**RE: Bryan County OEM Site
Bryan County, Georgia
Regulatory Branch #SAS-2015-00235**

In a letter dated 7 September 2018, the U.S. Army Corps of Engineers (USACE) provided comments received during the 30 day public notice associated with the proposed Savannah Harbor-Interstate 16 Corridor Joint Development Authority's (JDA) OEM project located in Bryan County, Georgia. As requested by the USACE, the JDA has reviewed each comment and has prepared this package in response to questions and/or comments received. The following identifies the commenting individual or agency and summarizes and provides a response to each outlined in each letter.

CONCEPTUAL RAIL ALTERNATIVE EXHIBIT
 BRYAN COUNTY MEGA SITE
 BRYAN COUNTY / GA

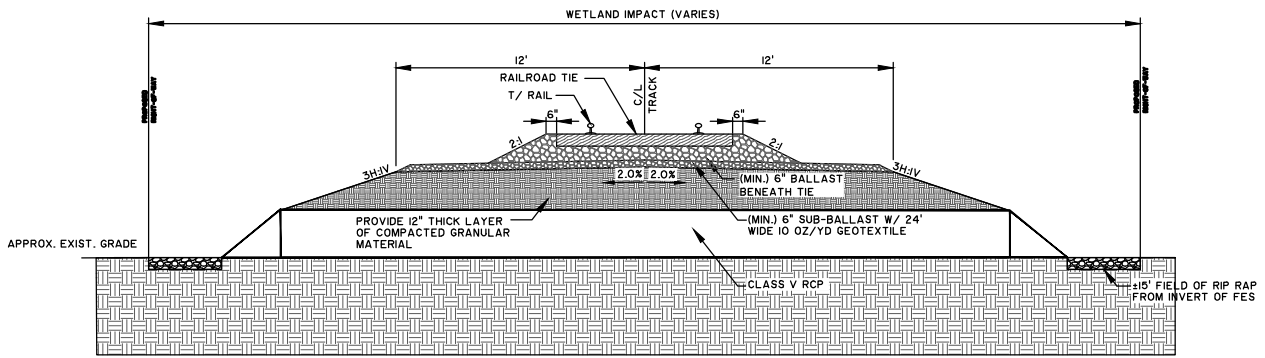
Georgia Department of Natural Resources-Environmental Protection Division: *In a letter dated 3 August 2018 EPD provided the following comments: With the need for such a large wetland mitigation credit purchase, and understanding that the cost of wetland mitigation credits is escalating, would it possibly benefit the applicant to investigate the areas generally south of the proposed rail spur alignment to see if there might be any upland zones still available for alignment shifts/refinement, even if different/additional property purchase would be required? We do understand that there may be property and geometric alignment constraints in this area, but we want to suggest this as an avenue of investigation that may possibly financially pay for itself if any notable lessening of wetland mitigation costs could be achieved.*

As concerns the railbed to be constructed for this railroad spur, whatever alignment is finally decided upon, we suggest and request that culverts/underpasses be employed in order to benefit wildlife passage and wetland hydrologic connectivity over this rather lengthy approximately 6,000 foot wetland crossing.

Response: The proposed project will be serviced by Genesee & Wyoming, Inc. (G&W) which is a short line railroad company. As part of the project design and review, the applicant and engineering team considered alternative rail routes that meet the service and rail access needs for the project and comply with G&W industrial track construction specification (see attached). Considerations included wetland impacts, habitat conditions, property ownership and fixed rail termini (rail must be located within the center of proposed facility and must connect to existing rail line). Four alternative routes were evaluated, and the following provides a brief summary of each:

Option A was proposed because it complied with rail specifications, avoided acquisition of additional property and avoided mature forested wetland habitat (required impacts to managed pine wetland). Option B was determined suitable and was preferred due to the direct linear access and reduced tract length. However, Option B required greater wetland impacts, required impacts to mature hardwood habitats and required acquisition of additional property from multiple property owners. Option C was determined suitable but required acquisition of additional property and during discussions between the JDA and the property owner, the property owner raised objections to the proposed corridor bisecting/fragmenting the property. Option D evaluated installation of the rail line on the northern portion of the property at the request of the applicant. This alternative alignment avoided bisecting the property but does not comply with rail construction specifications (greatly exceeded minimum slope and radius requirements). For these reasons, Option A was determined to be the only practicable corridor for rail access.

CONCEPTUAL LAYOUT EXHIBIT - A
BRYAN COUNTY MEGA SITE
BRYAN COUNTY / GA

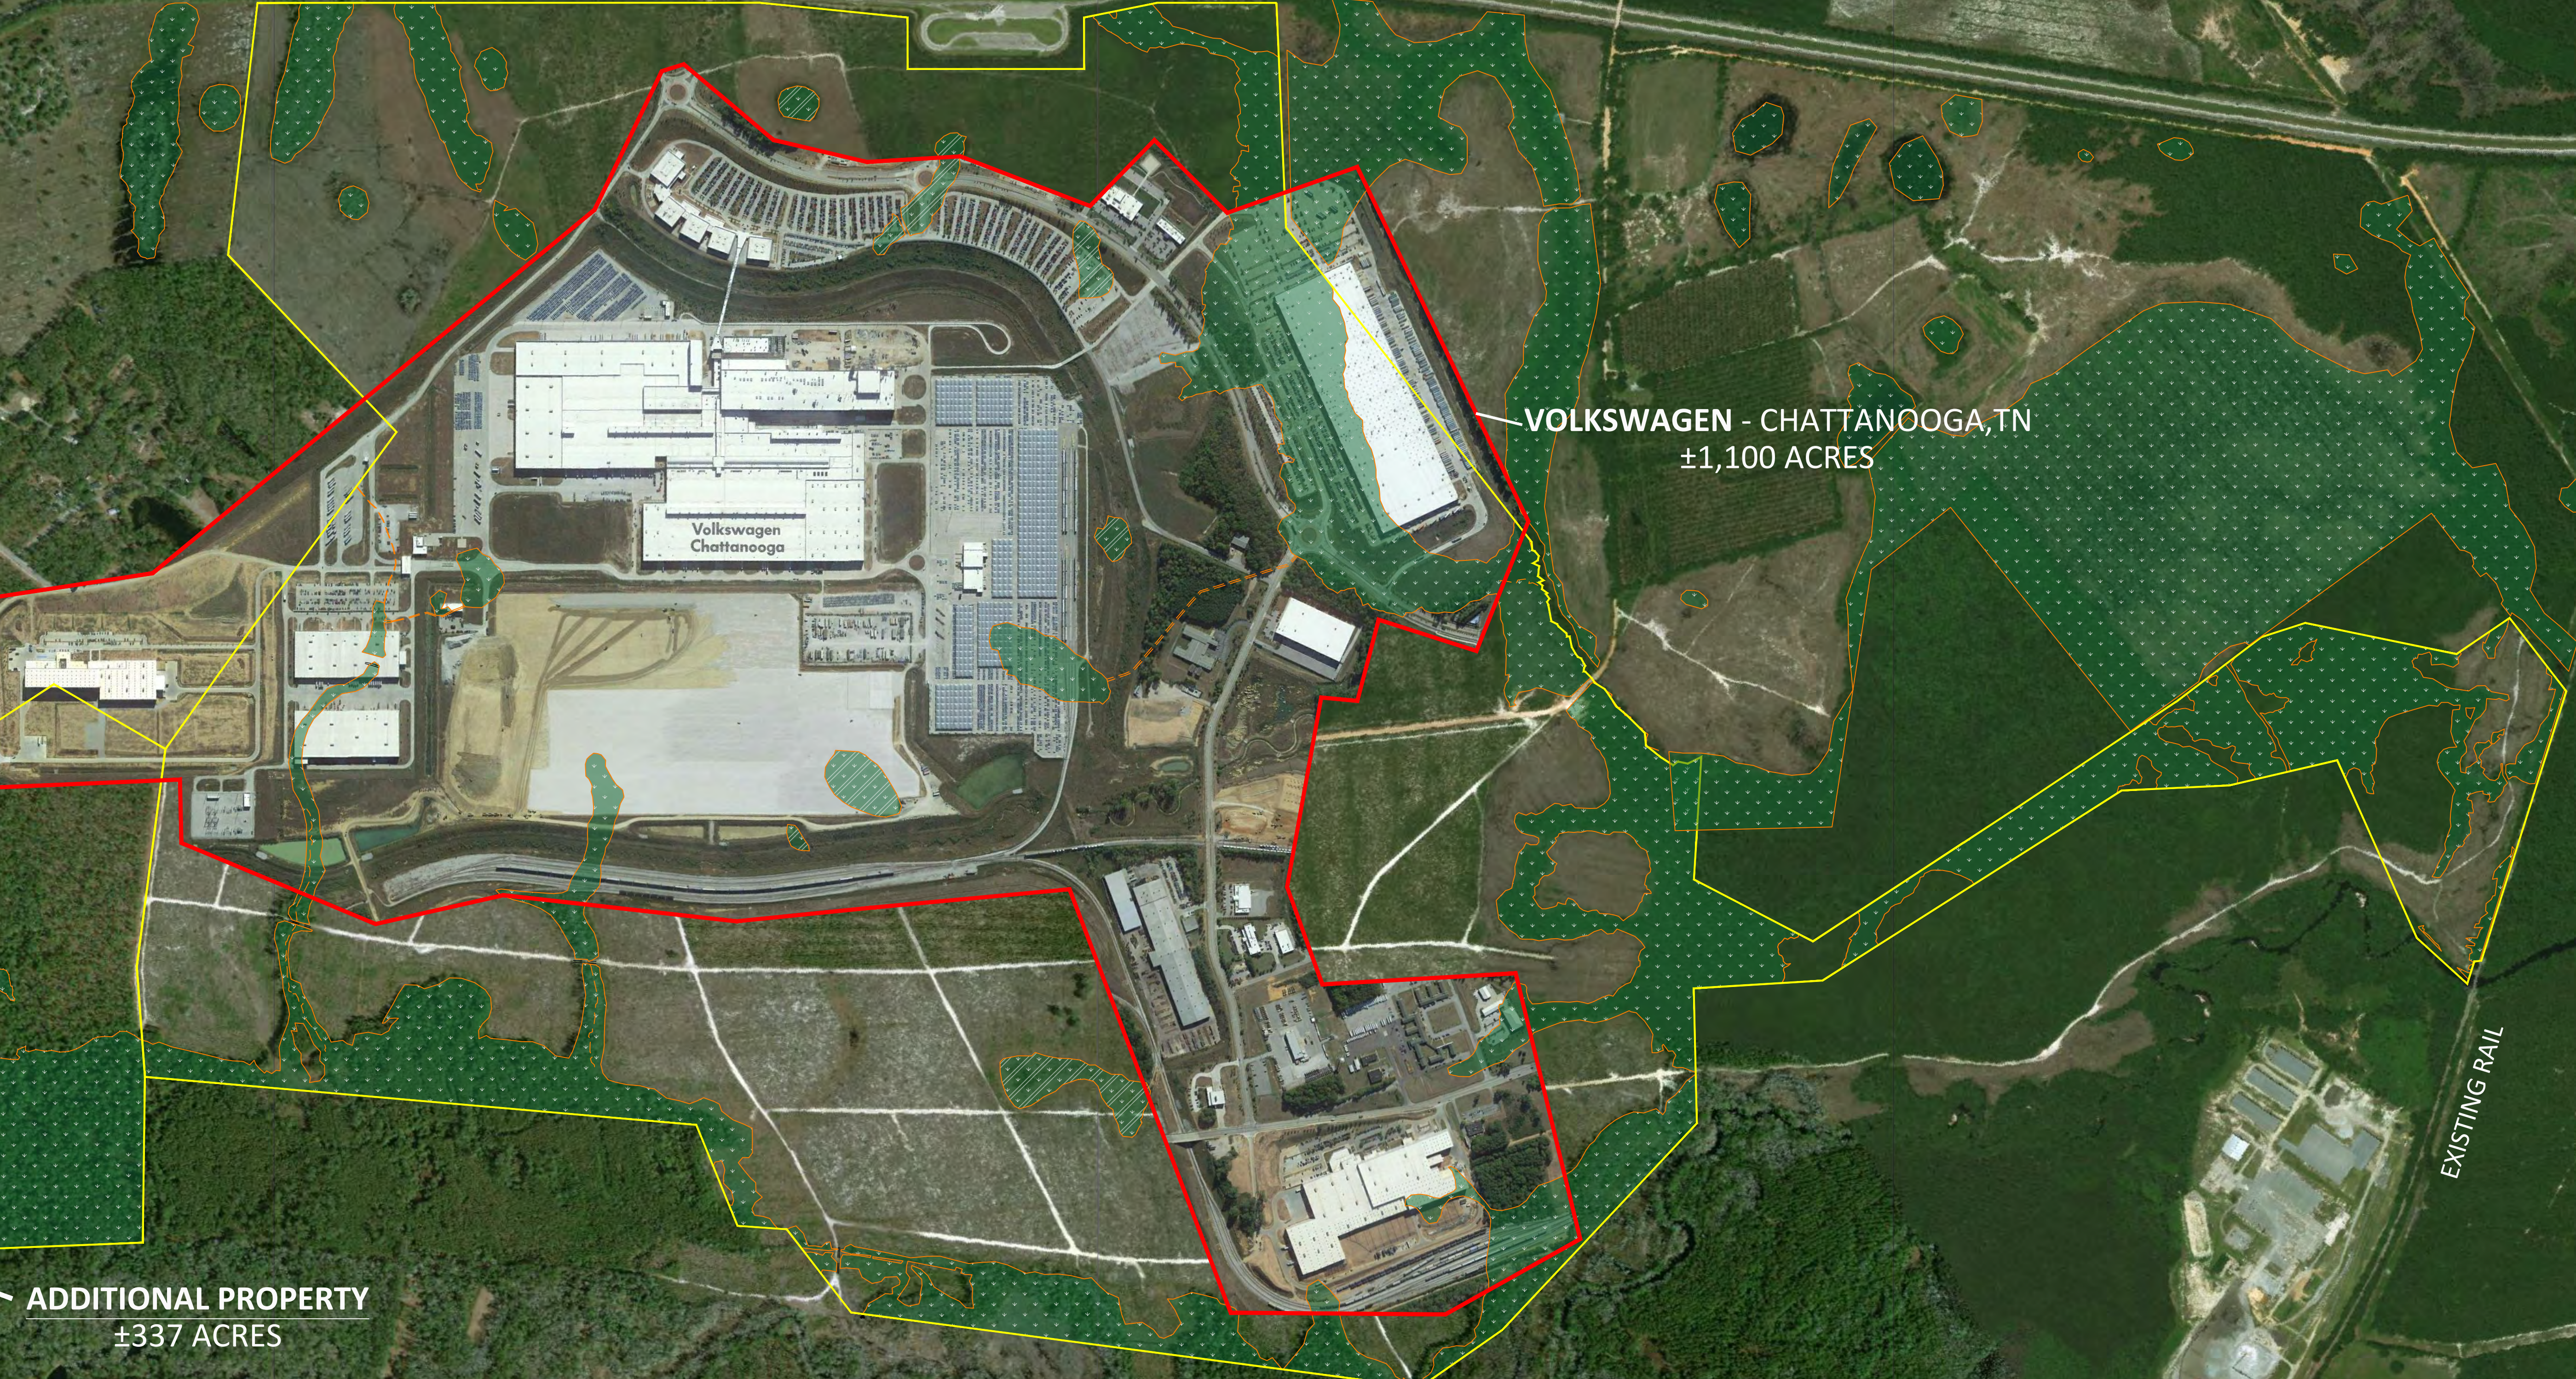
Comment: *What the applicant is asking the Corps and the public to do is assume that any future tenant would build its facility with the same footprint as the fictional plan included in the application. It is one thing to analyze a proposed project where there is a potential tenant that has made some commitment to building on the site. It is entirely another thing to seek approval for a permit when there is no potential tenant considering the site.*

Comment: *Moreover, a careful examination of the fictional rendition shows that many of the wetlands impacted on the site could be protected if building footprints, parking lots, and rail spurs were realigned. But again, how can one have a useful conversation about such realignments? Ultimately, any future tenant's facility may look much different than the facility included in the application. It is in the interest of the Applicant. By doing so, the Applicant can provide greater flexibility to any future tenant. The tenant may decide to spread out its facility if it already has authorization to fill wetlands that would otherwise have gotten in the way. In this way, a future tenant could, in effect, circumvent avoidance and minimization.*

To demonstrate the size and scope of these facilities, five existing manufacturing facilities from various locations across the southeast were overlaid on the project site. While the configuration varies (primarily due to topography), the exhibits clearly justify the proposed project's size and scope.
